Re: Greenway Environmental Services, LLC  
Green Meadow Sustainable Solutions Landfill  
Solid Waste Application Deficiency  
Jefferson County, Mississippi  
Permit No. SW0320040549

On behalf of Greenway Environmental Services, LLC (Greenway), Allen Engineering and Science, Inc. (AllenES) is submitting this letter to address application comments and concerns previously made by the MDEQ in a letter dated October 2, 2025 regarding the December 15, 2024 Revision 0 Permit Application Report (PAR). Listed below are the comments (previously made) along with a response.

| LEGEND |                                                                                                              |

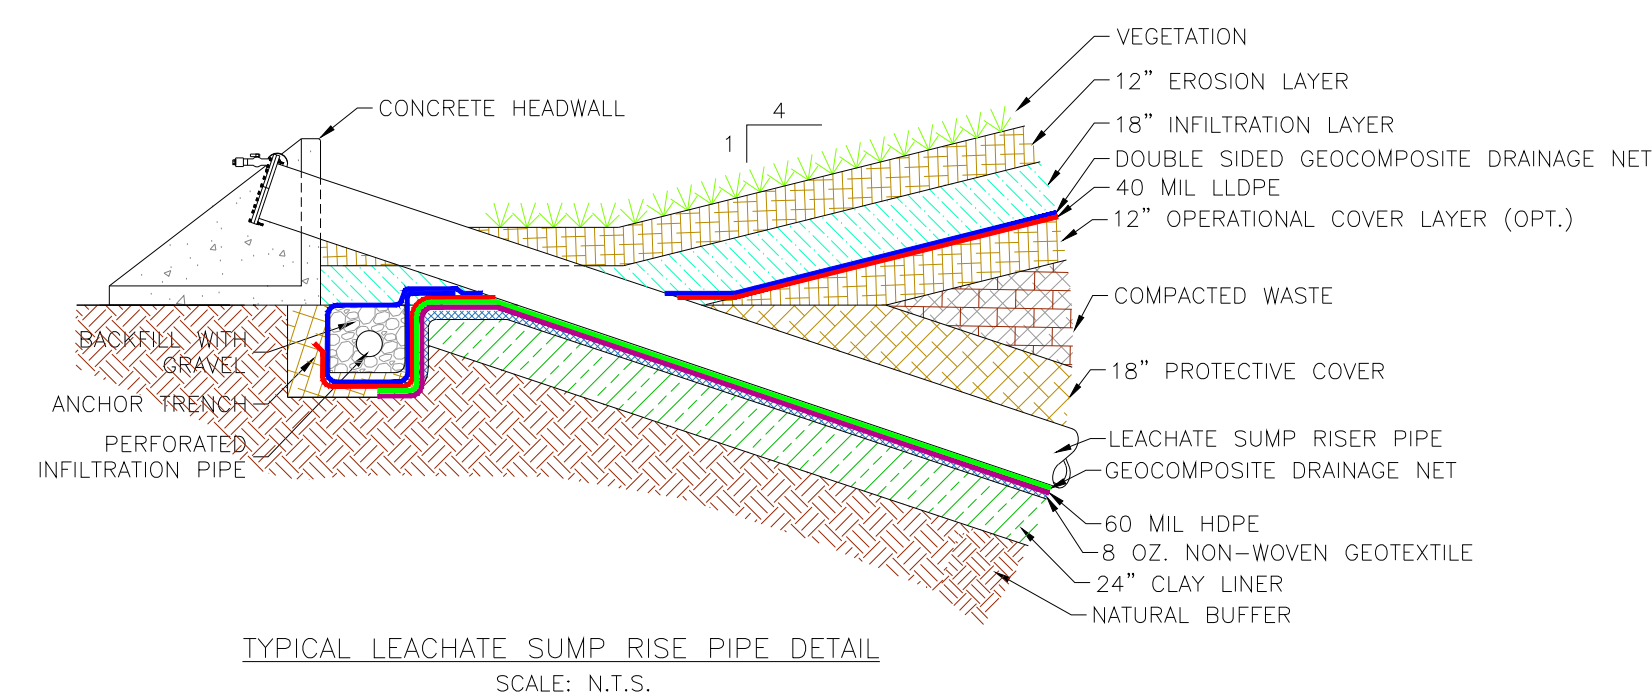
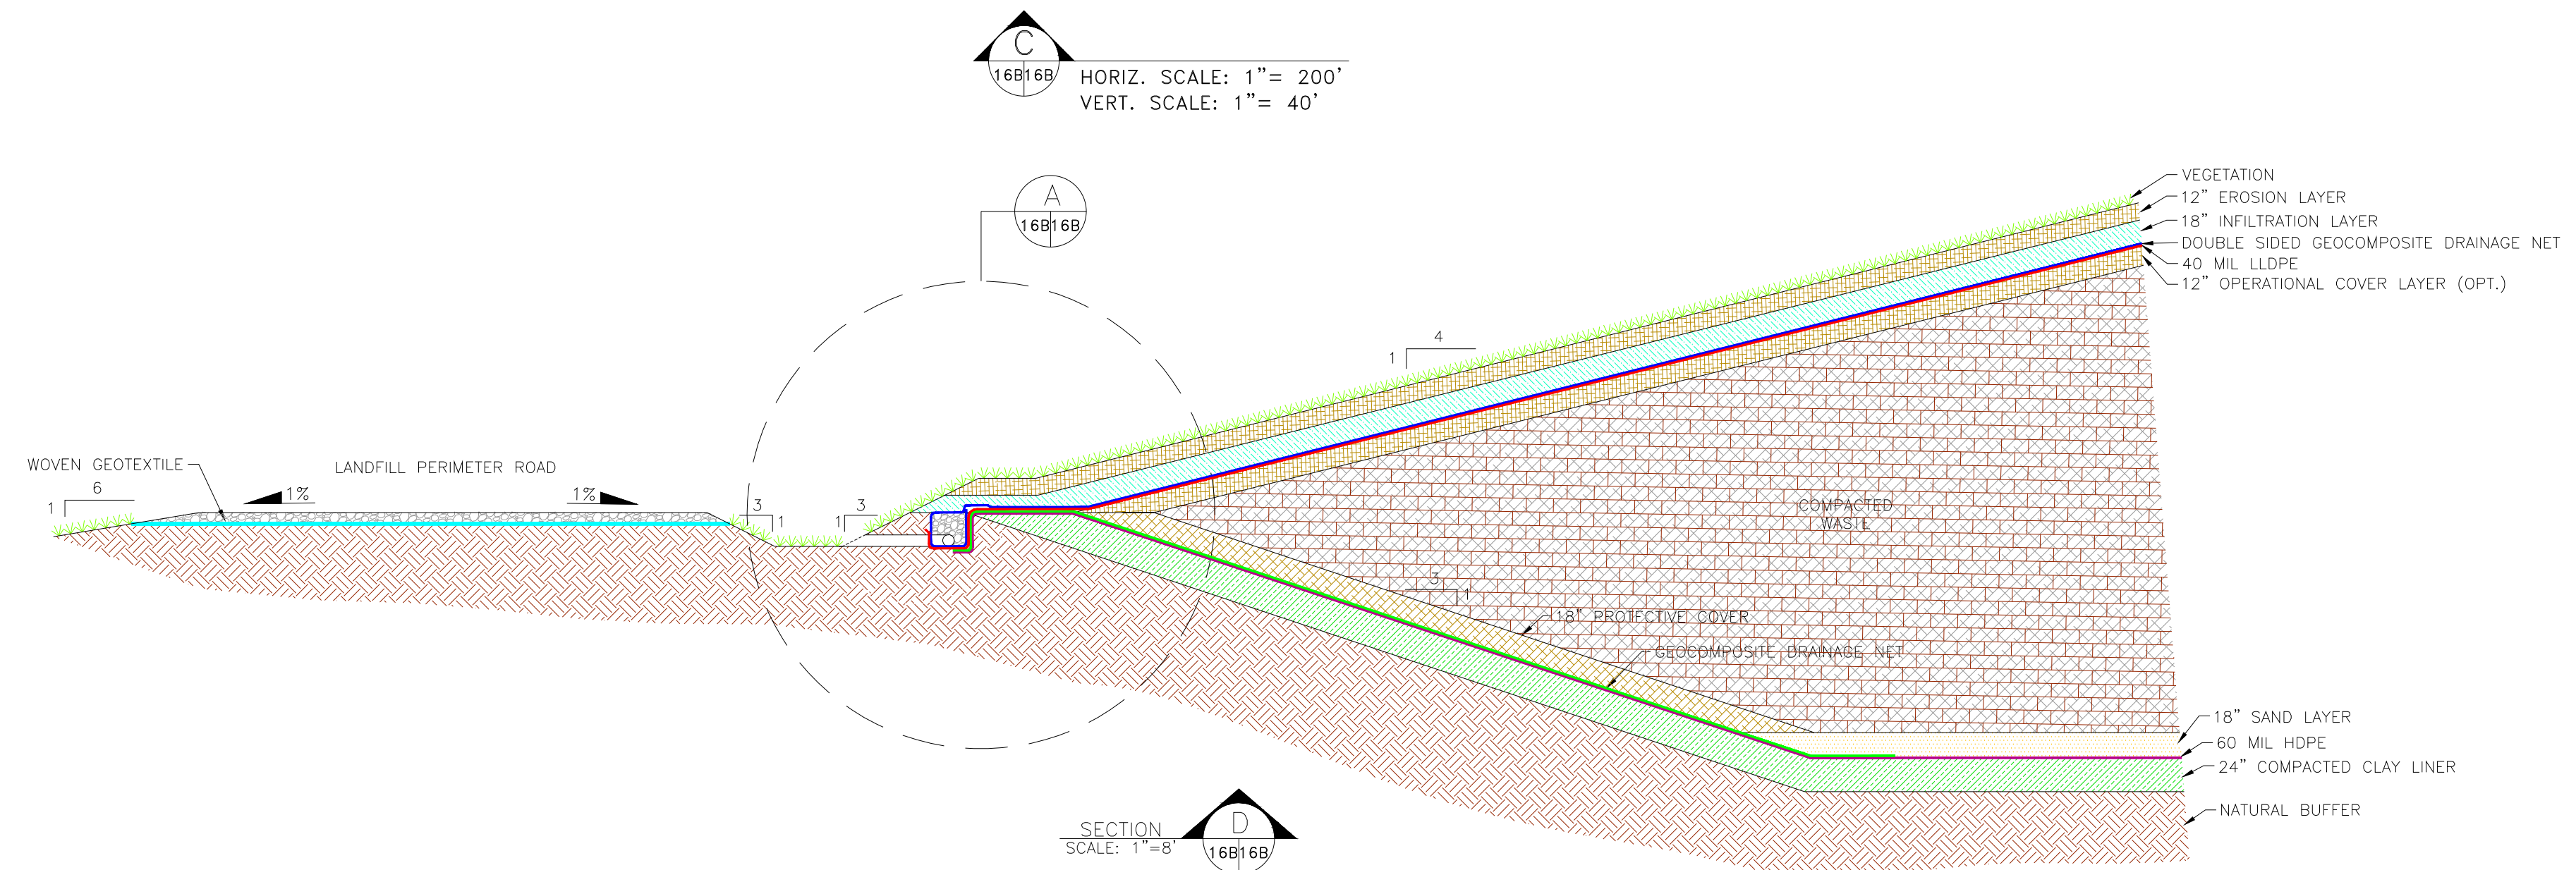
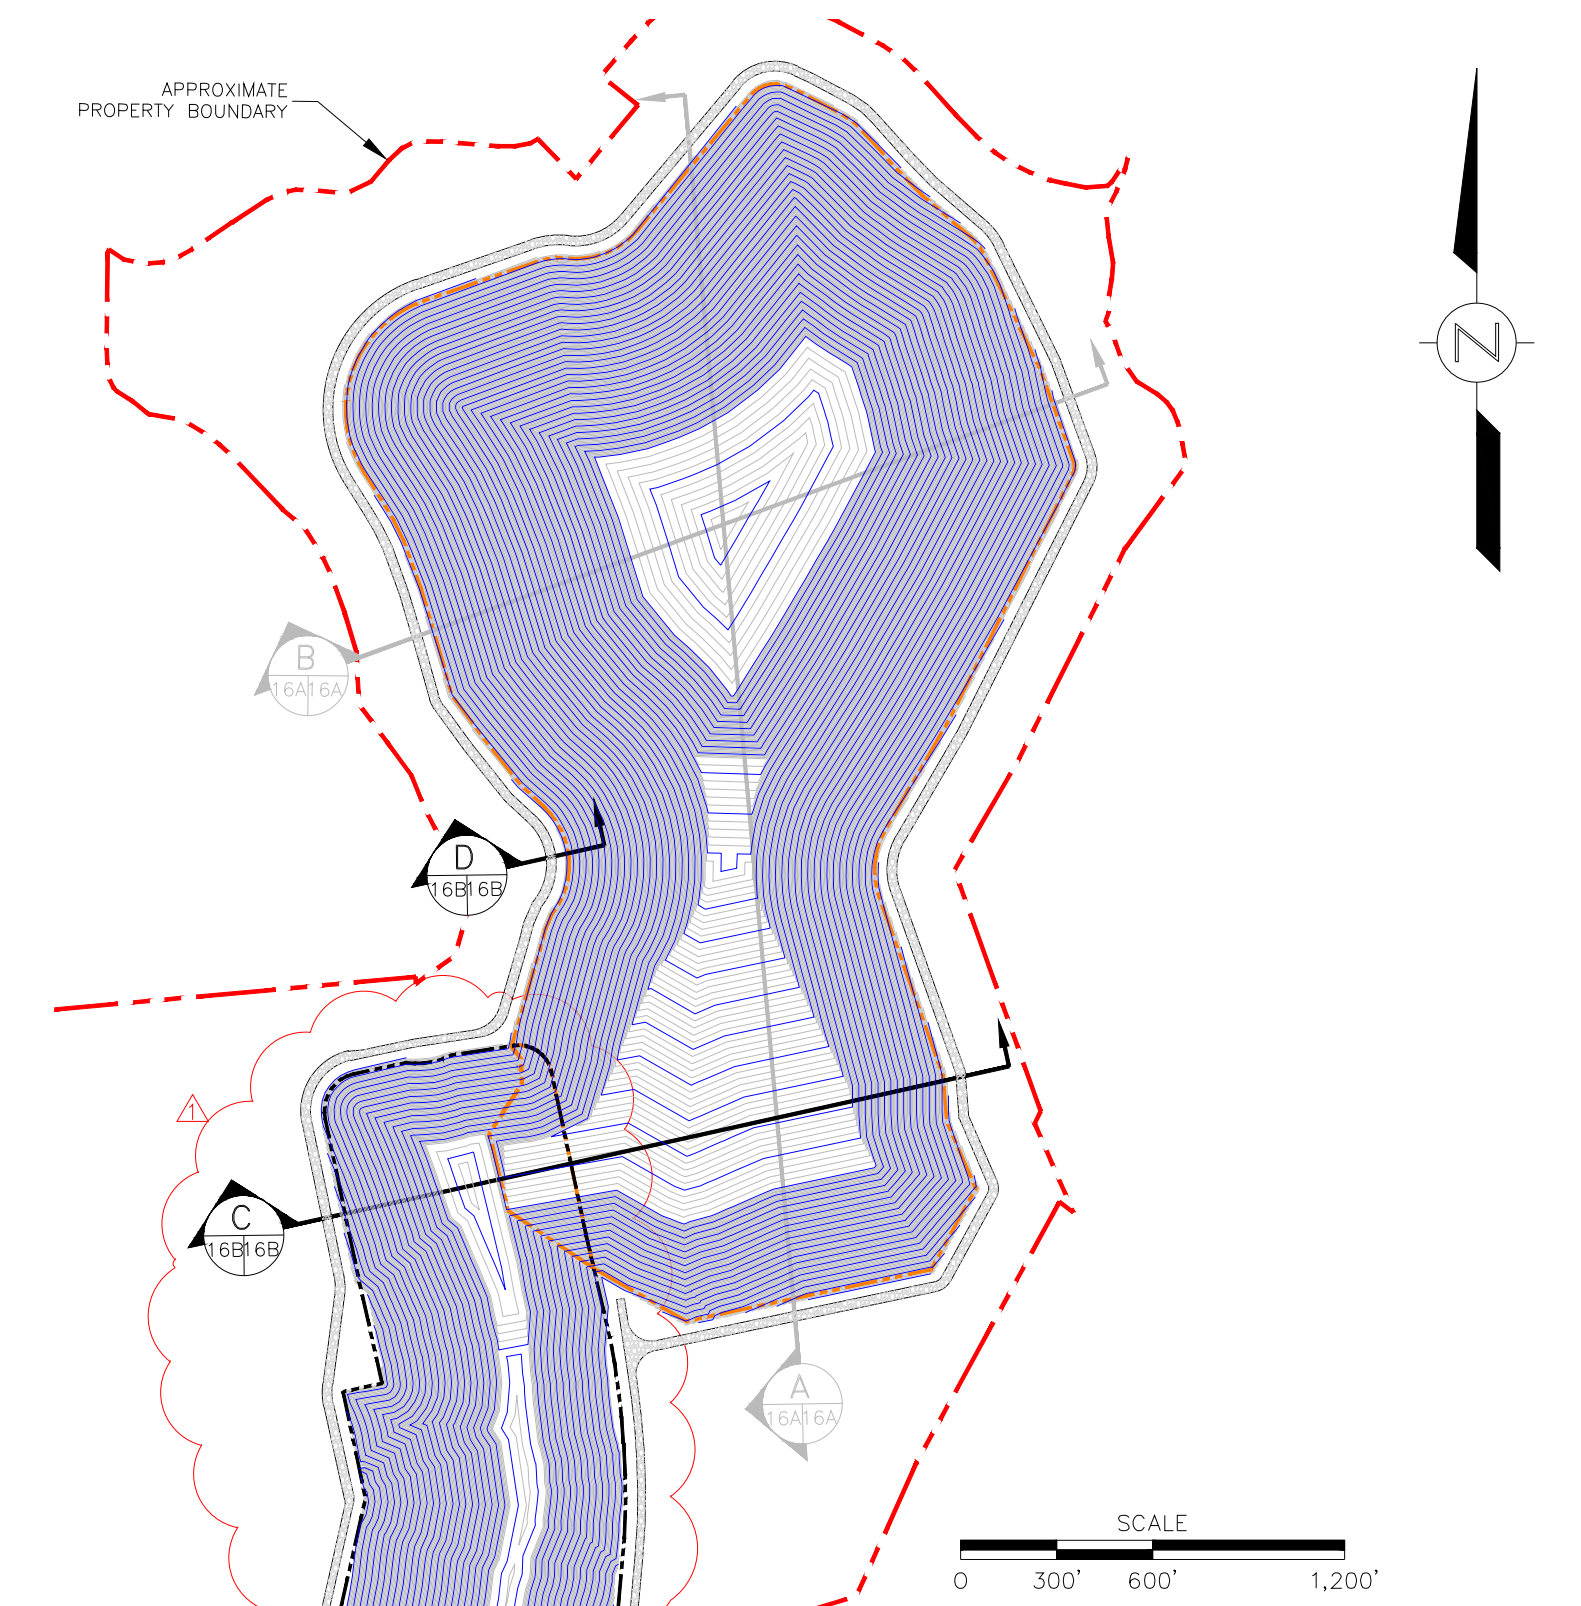
**14. Drawing 16B – External side slopes do not coincide in the referenced sections. Please revise.**

AllenES has updated Drawing 16B to address the Department's comment. The revised Drawing 16B has been included in **Appendix L**.

| DRAWING<br>19                           | REVISION<br>1 |

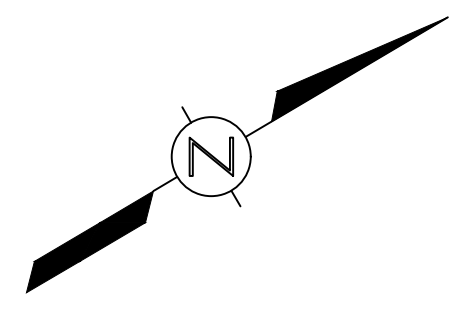
**15. Drawing 19 – Please specify the well diameter for landfill gas extraction wells.**

AllenES has updated Drawing 19 to specify the landfill gas extraction well diameter. The revised Drawing 19 has been included in **Appendix L**.

- NOTES:  
1 EXACT LOCATIONS OF GAS EXTRACTION WELLS WILL BE IDENTIFIED DURING LANDFILL GAS MANAGEMENT SYSTEM DESIGN.
